**Planning & Zoning Commission
Tuesday, September 5, 2023, 6:00 PM
Public Meeting Room / Eagle Town Hall
200 Broadway, Eagle, CO 81631**

1. Project: 882 Chambers Ave.
File # DR23-05
Applicant: Mike Mootz, Owner
Location 882 Chambers Avenue
Staff Contact: Cliff Simonton, Senior Planner

Request: A Minor Development Permit to construct the shop buildings with attendant parking and landscaping on a 1.125 acre lot on Chambers Ave.

Elevation looking from the north (Chambers Avenue). The “L” layout is not evident - Building A on the right side of the drawing is offset 100 feet to the rear of the entrance façade for Building B, which is on the left

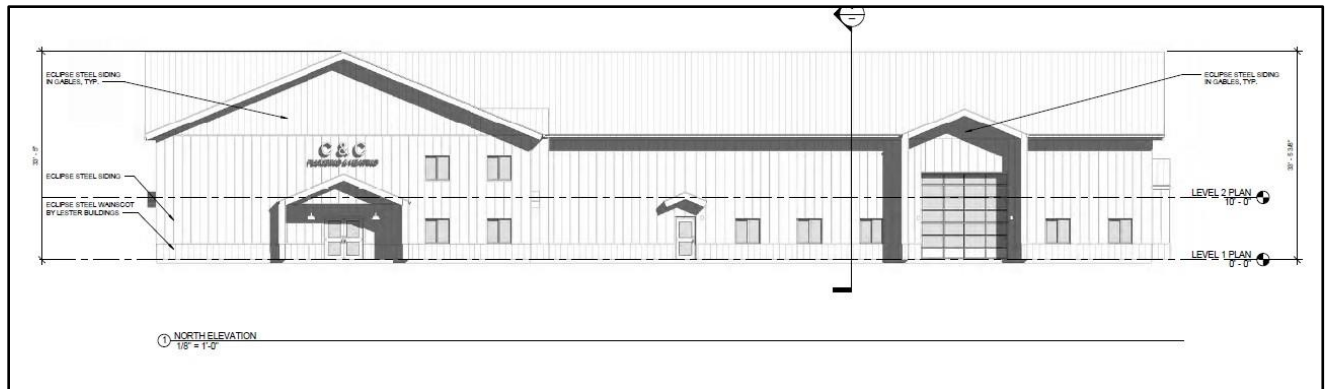
Staff Comment: Simple rectangular buildings are proposed with gable roof forms. The applicant has incorporated several design features to provide variety and visual interest including a simulation vertical board and batten siding, building projections around main entrances and garage doors, smaller gable roofs at each secondary entrance, and a contrasting wainscot around the base of the structure.

Staff Comment: The façade for Building B that faces Sawatch Road is 100 feet in length, and is broken by walls that project three feet on either side of a central large garage door. Windows and smaller secondary doors with gable roofs also break the plane of this façade. While Building A is longer, much of it is hidden from view by Building B, with only 100 feet of its north facing wall visible from Chambers Avenue. This wall is similarly broken by wall projections on either side of a central large garage door which is covered by a gable roof form. Windows and smaller secondary doors with gable roofs break the plane of Building A's north facing façade. The buildings will be clad in metal siding designed to replicate vertical board and batten siding, and 24" roof overhangs will cast shadows throughout the day. Additionally, a wainscot in contrasting dark color will surround the base of both structures.

Staff Comment: A simple gable roof form is proposed for both buildings, incorporating a 5:12 roof pitch. Large garage door entrances on both buildings will be covered by separate gable roofs covering wall extensions that frame each door, adding interest to the overall form. Each building will have a projecting primary entrance feature covered with a secondary gable roof form. Exit doors located around the building perimeters will each have a small gable roof.

SITE PLAN

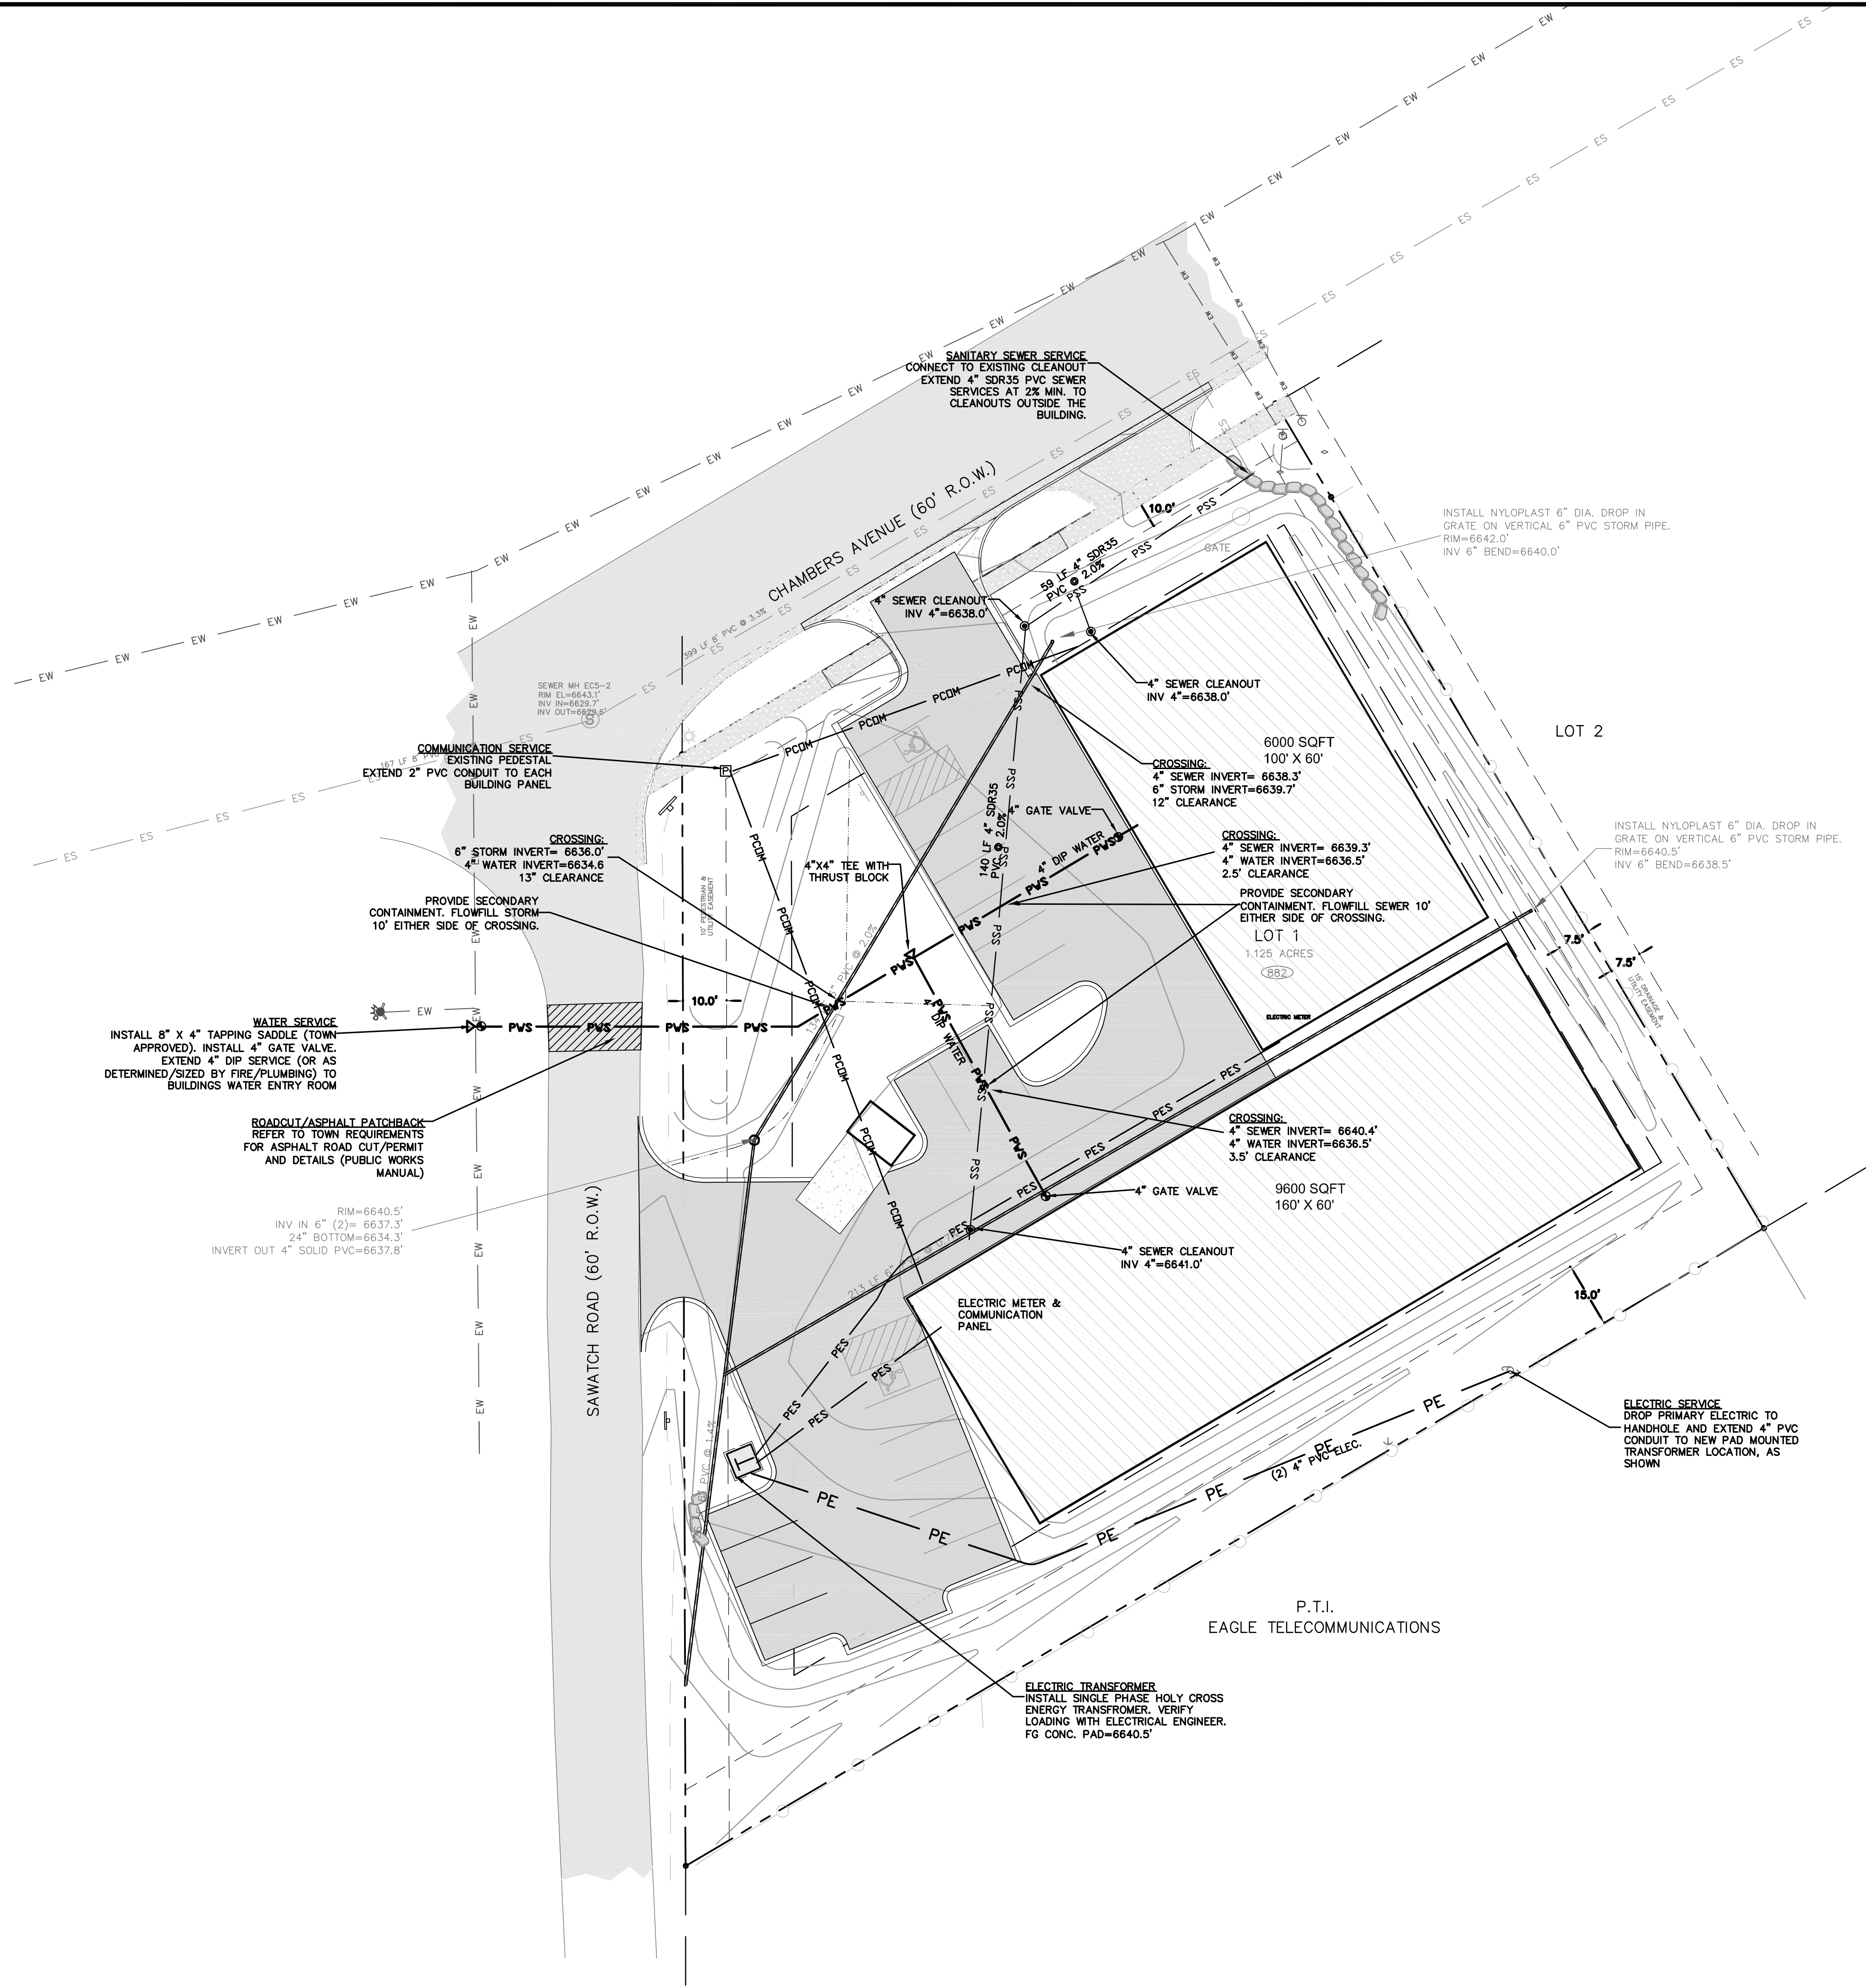
Staff Comment: As a corner lot, this property has two front yards, one on Chambers and one on Sawatch. The rear yard for this project was selected by the Applicant as the southern lot line. The side yard was selected to be on the east; the side yard setback is 17 feet due to a proposed building height of 33.5 feet. All dimensional standards will be met by the proposed design.

Staff Comment: Eighteen parking spaces are required for the two buildings, and 20 are proposed. Parking will be straight in, with spaces 9 feet wide and 19 feet deep. Two dedicated handicapped parking spaces with ground identification and signage are in that mix, located near the primary entrances to the buildings. The ADA spaces are 17 feet wide and 19 feet deep. All travel surfaces and parking areas will be paved with asphalt. Parking as proposed meets the requirements of the Code.

Staff Comment: Access entrances, one from Chambers Avenue and the other from Sawatch Road (the exit), will be approximately 22 feet wide. The access points are no closer than 70 feet to a side property line. Vehicles will enter and exit parking areas in forward drive, and parking areas will be screened from the adjacent roadways with landscaping trees and shrubs. Although each proposed lot holds 10 cars, there are no more than 7 contiguous parking spaces in either. Planting a tree internal to the lot is not practical

BUILDING ELEVATIONS

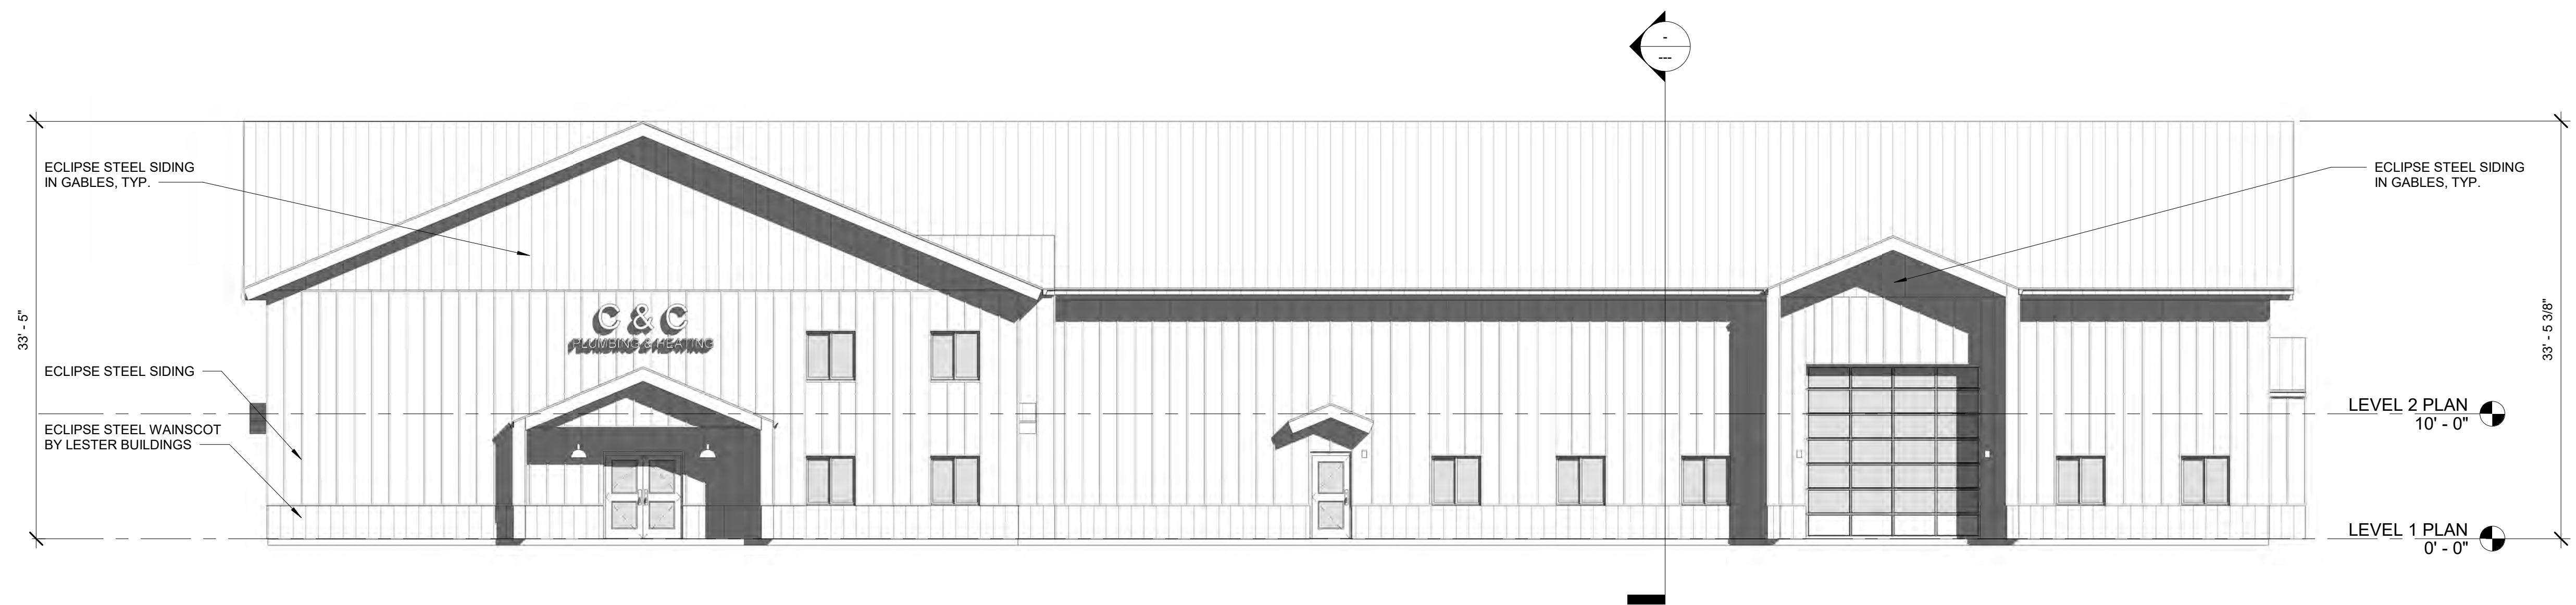
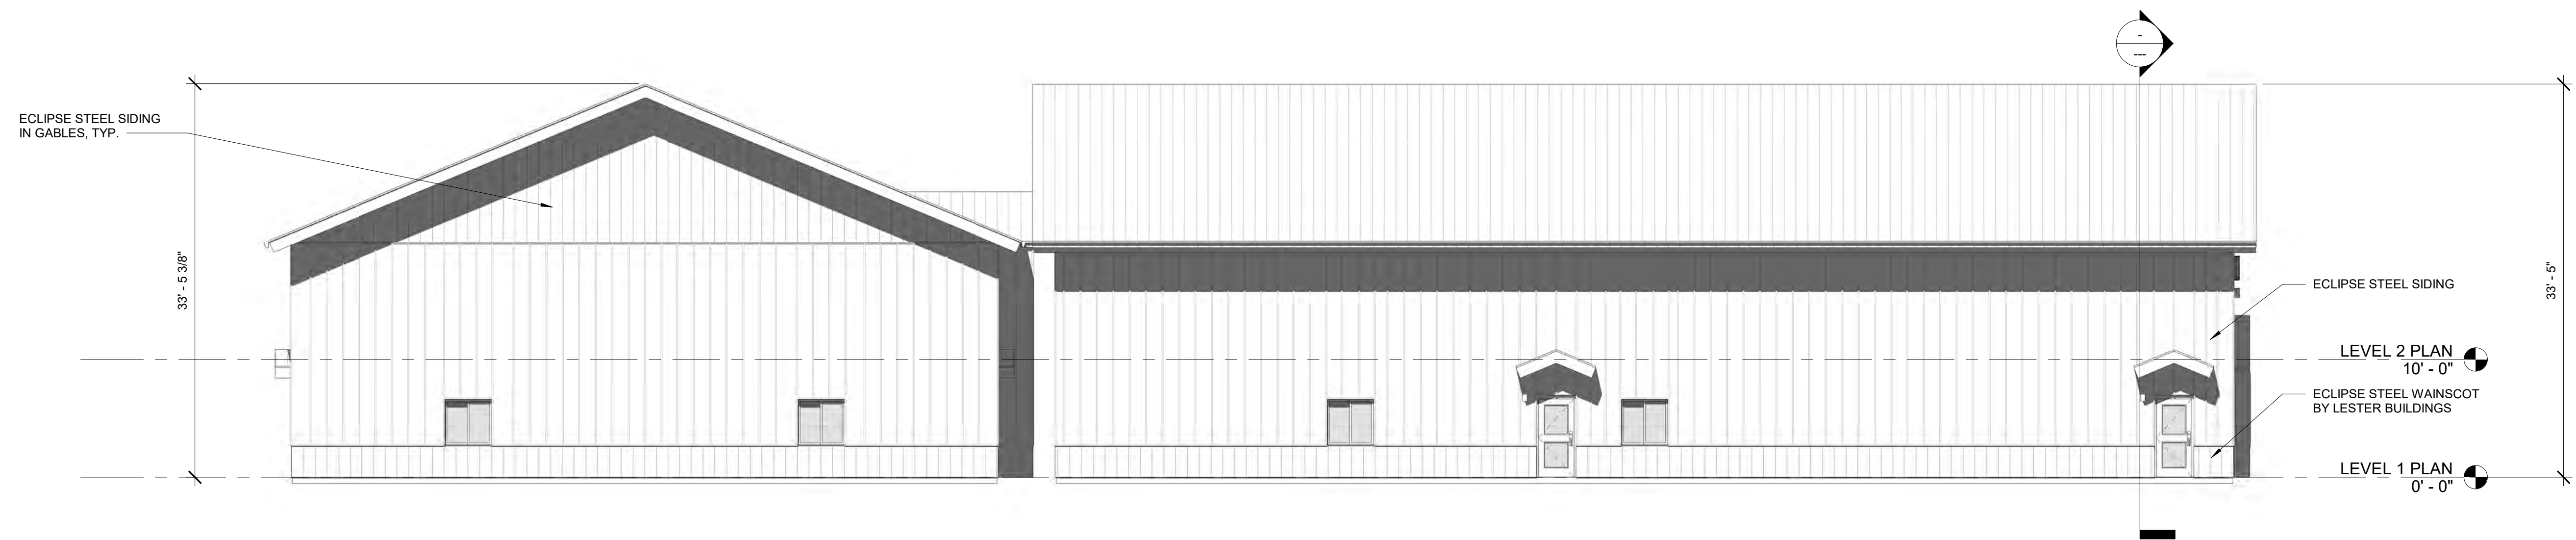
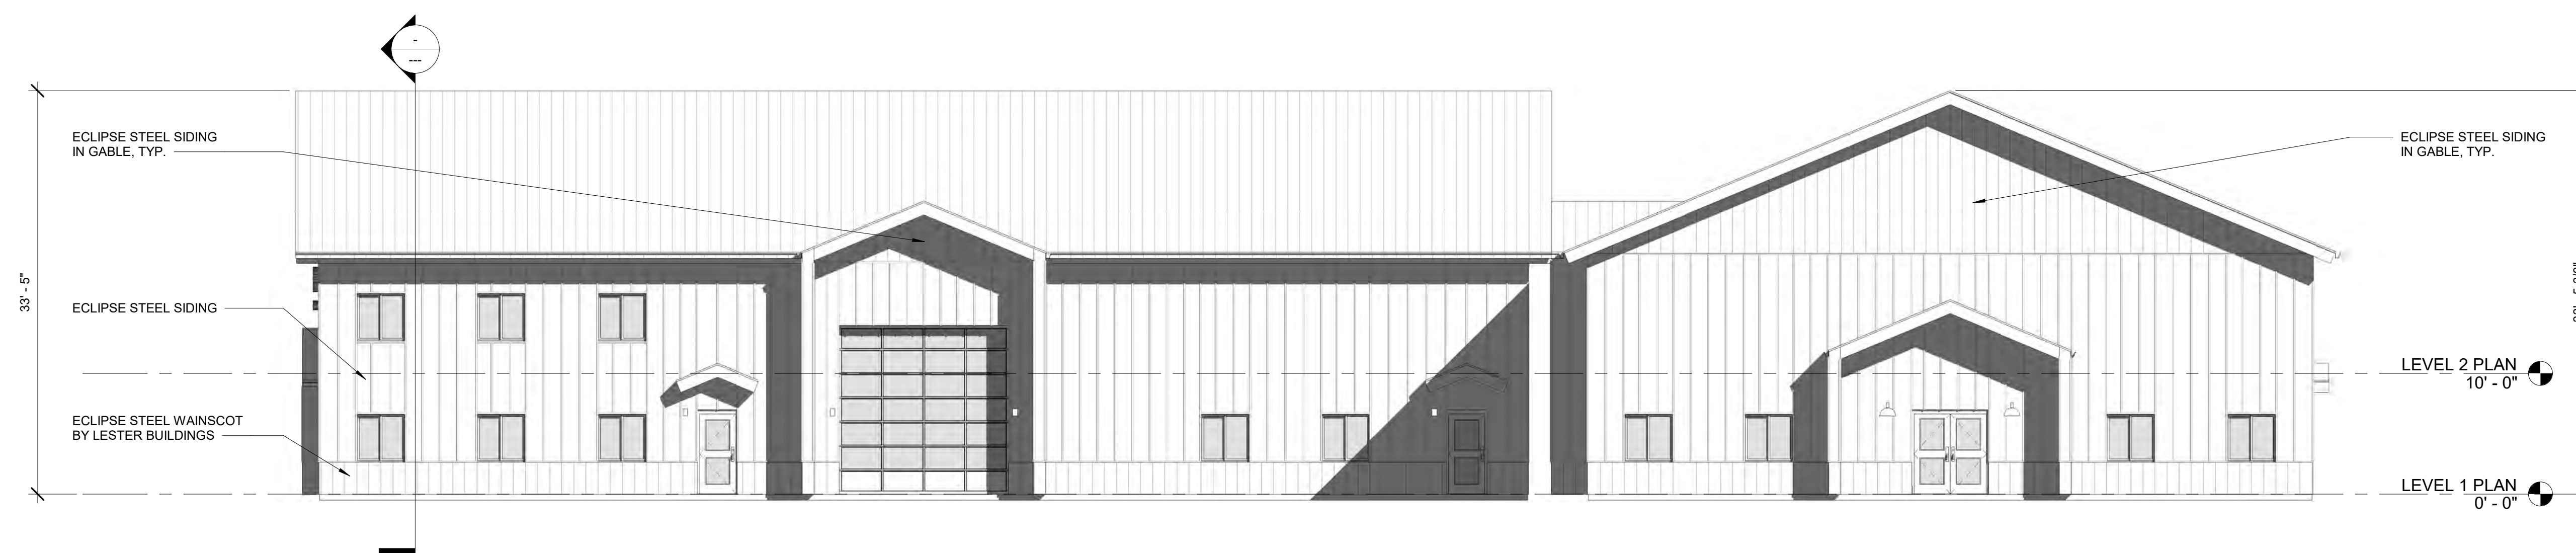
Staff Comment: The proposed shop buildings are each 33.5 feet high at the gable ridge (apex), and well within the stated standard.

Staff Comment: Metal siding is proposed, using product manufactured by Eclipse Roofing Systems. The material profile is flat with raised ribs intended to replicate vertical board and batten siding. Siding color will be grey, with a black wainscot below the lower window levels. A white standing seam metal roof is proposed for both buildings. All materials will have low reflectivity.
